**SNAKE RIVER PLAIN AQUIFER
MODEL SCENARIO:**

THE SOURCES OF DRAWDOWN AT A&B
“A&B Scenario”

May, 2005

Appendix 1 HDR Comments

Figure 2. Drawdown at A&B due to pumping within the A&B service area only.

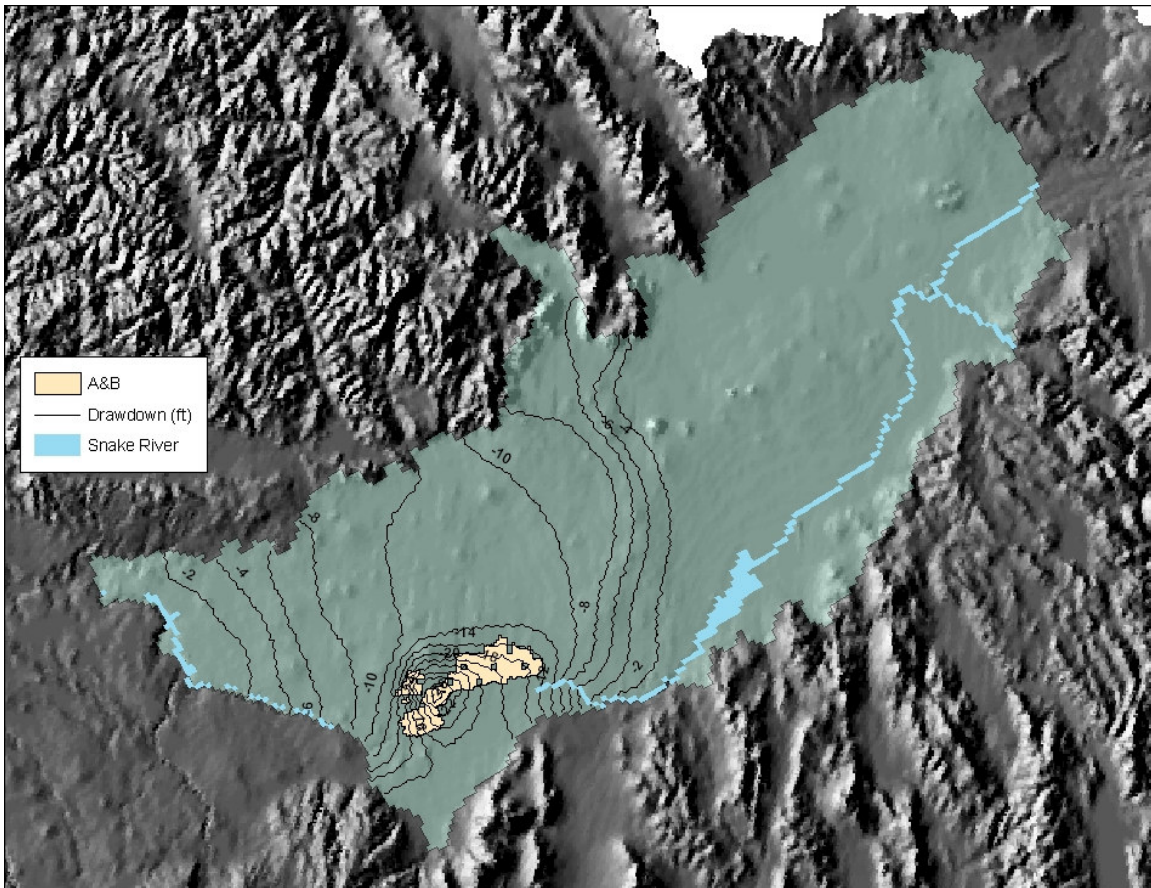
We understand that drains are not included in the super-position analysis. If this is the case, please remove the drain cells from Figures 2 to 4.

The predicted drawdown shown in Figures 2 to 4 exceeds the observed drawdown in the aquifer at areas near A&B Irrigation District and south of the District. Please explain these results.

Accept.

Accept. I will add an explanation to the summary section.

Figure 3. Drawdown at A&B due to all other ground water irrigation.

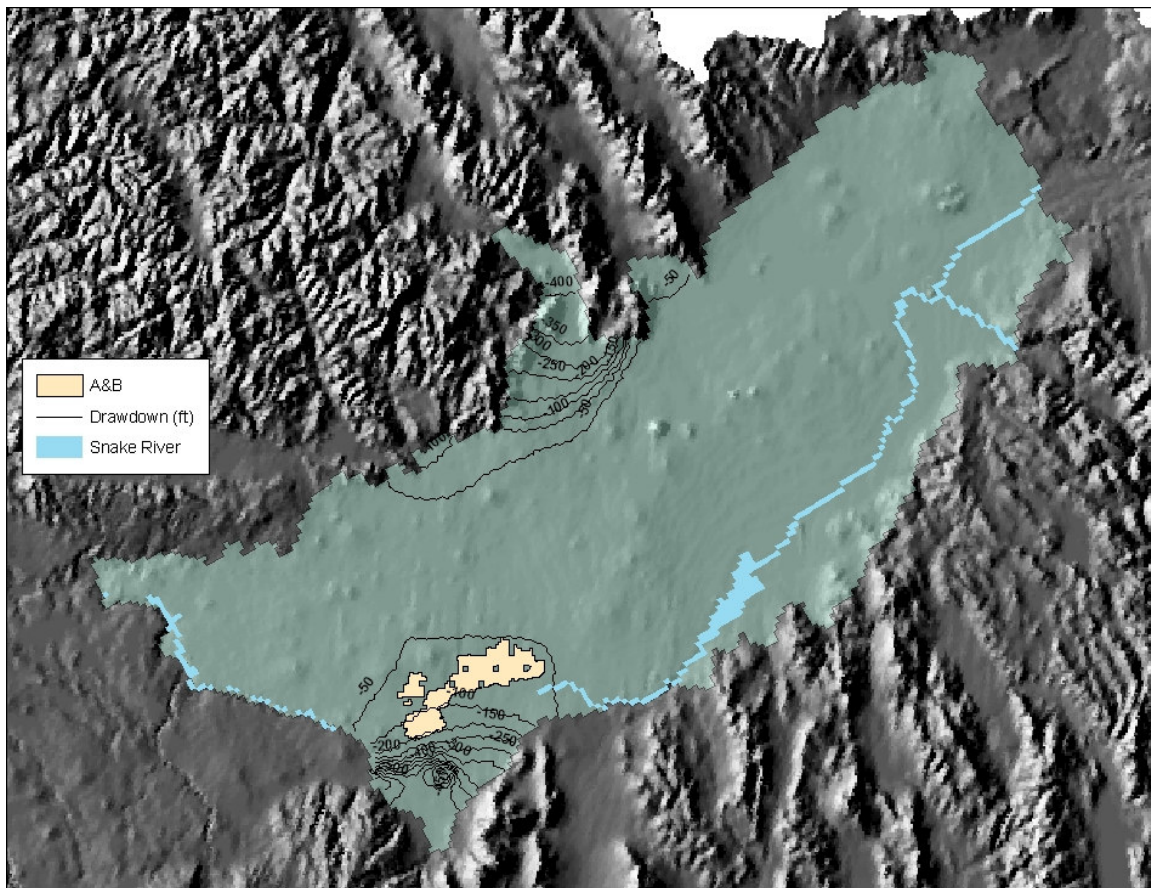
The scenario results in Figure 3 seem to show boundary effects in the Oakley Fan and Big Lost River area. Please explain.

Accept. We will add a paragraph to that effect in the “others” scenario.
